LINCOLN CITY/LANCASTER COUNTY PLANNING STAFF REPORT

P.A.S.: Preliminary Plat #01015 - Thompson Creek **DATE:** January 9, 2002
Special Permit #1930
Use Permit #141
Change of Zone #3338
Change of Zone #3339

<u>PROPOSAL:</u>	Change of Zone #3338	AG to R-3
	Change of Zone #3339	AG to O-3
	Preliminary Plat #01015	283 residential and 2 office lots
	Special Permit #1930	312 assigned units; 40 unassigned
	Use Permit #141	69,000 sq. ft. of office
		live/work dwellings

THOMPSON CREEK **PRELIMINARY PLAT & C.U.P**

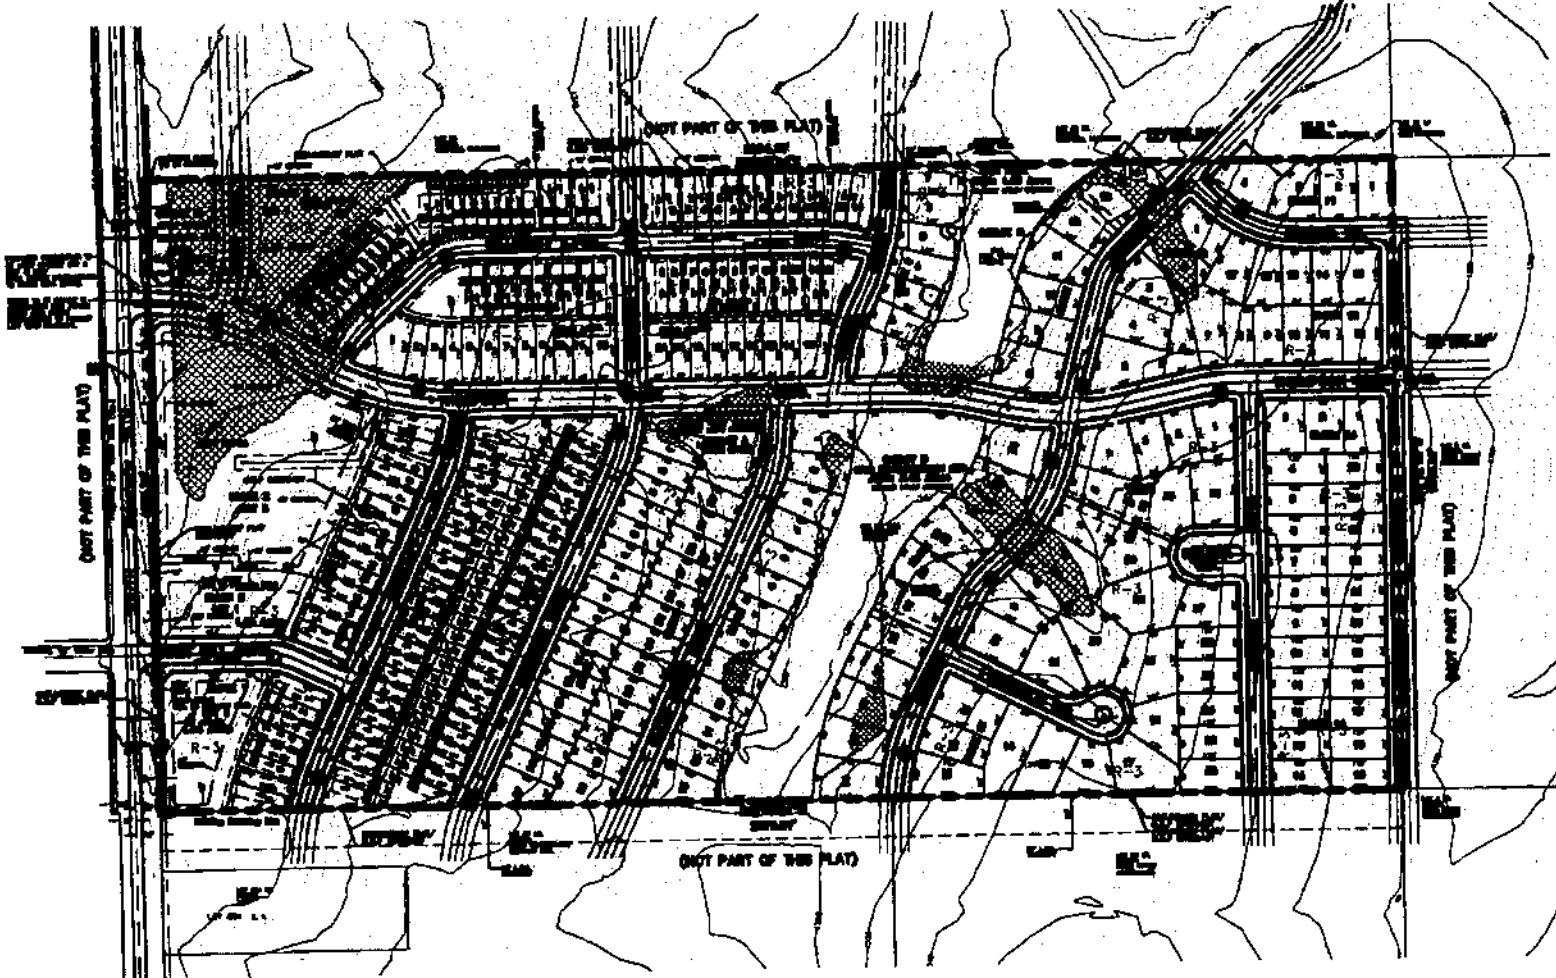
3. The proposed development generally meets the intent of the ordinance.
4. The live/work townhouses on the north side of Billings Drive should be rearranged to face each other rather than lining one side of the street. Outside employees are not permitted in the R-3 zoning district, so the townhouse area should be zoned O-3 and included with the use permit. If the live/work concept is not developed, that area should revert to R-3 zoning and uses. The parking requirement for the office uses can be waived; the residents will use the rear-entry garages and any clients would use the on

5. The residential alleys are too wide. The Subdivision Ordinance requires 20 feet of right-of-way for alleys, but not all of that needs to be paved. The residential alleys in Vavrina Meadows 1st Addition are 16 feet wide, for example.

6. The alley in Block 5 is approximately 900 feet long. There should be a break somewhere near Lots 10, 11, 39 and 40. This will facilitate access to the houses at the center of the block. The corner lots appear wide enough to accommodate 20 feet of north south alley. The cost of constructing the additional alleys can be offset by providing narrower alley widths.

7. Thompson Creek Boulevard is a long, wide fairly straight street which will encourage speeding. The right of way east of Greycliff Drive should be reduced to 60 feet and the pavement width reduced to 27 feet. The width reduction saves the developer the cost for 22,800 square feet of concrete.

10. The proposed sanitary sewer does not meet maximum depth design standards. Public Works & Utilities notes that having downstream property that has not constructed sanitary sewer is not sufficient justification for waiving the design standards. The development of the western portion of this plat should not occur until an outlet sewer is constructed in the natural drainage basin.

11. The lots adjacent to Detention Cell 1 would be flooded by the 100 year ponding elevation. This must be corrected.

14. Public Works & Utilities notes that the right angle parking, with its limited sight distance and proximity to a horizontal curve, creates potential conflicts with traffic. The townhouse area along Billings Drive must be revised so that there is sufficient room within the right-of-way for a sidewalk as well. If the 45 right angle parking stalls were removed, Billings Drive would permit approximately 27 spots for parallel parking on the north and 22 spots on the south (assuming 20 feet per parking spot). The proposed right angle parking might provide more convenience and parking stalls for drivers accustomed to standard office and commercial developments, but it carries a reduction in traffic safety.

- 1.1 Revise the preliminary plat to show:
 - 1.1.1 Easements requested by L.E.S.
 - 1.1.2 Delete Note 30, which is redundant.
 - 1.1.3 Revise Note 14, the site plan, and the Thompson Creek Boulevard cross section to show 60 ft. of right-of-way and 27 ft. pavement width east of Greycliff Drive.

- 1.1.10 Revise the sewers so that they do not exceed maximum depth.
 - 1.1.11 Add a note to the site plan stating that construction of the western portion of the development shall not occur until an outlet sewer is constructed in the natural drainage basin.

- 1.1.12 Revise the grading and drainage plan so that it is satisfactory to Public Works & Utilities.
- 1.1.13 Provide traffic generation information including turning movements for Thompson Creek Boulevard and Union Hill Road.
- 1.1.14 Remove the 90 degree parking from Billings Drive and widen the street to local commercial standards where it abuts the live/work units.

- 1.1.1 Dimensions for the multiple family dwellings.
 - 1.1.2 Provide detailed plan for the playground space, including scale.
 - 1.1.3 Reduce the alley paving width. 20 feet may be appropriate for the portions of the plat where residences and commercial uses share alleys, but other residential subdivisions feature narrower alleys (16 feet in Vavrina Meadows, for example).

- 1.1.6 Add a north-south alley between Lots 39 and 40, Block 5. This will better serve the lots at the center of the block.
 - 1.1.7 Revise the area of the C.U.P. to exclude the proposed live/work units.
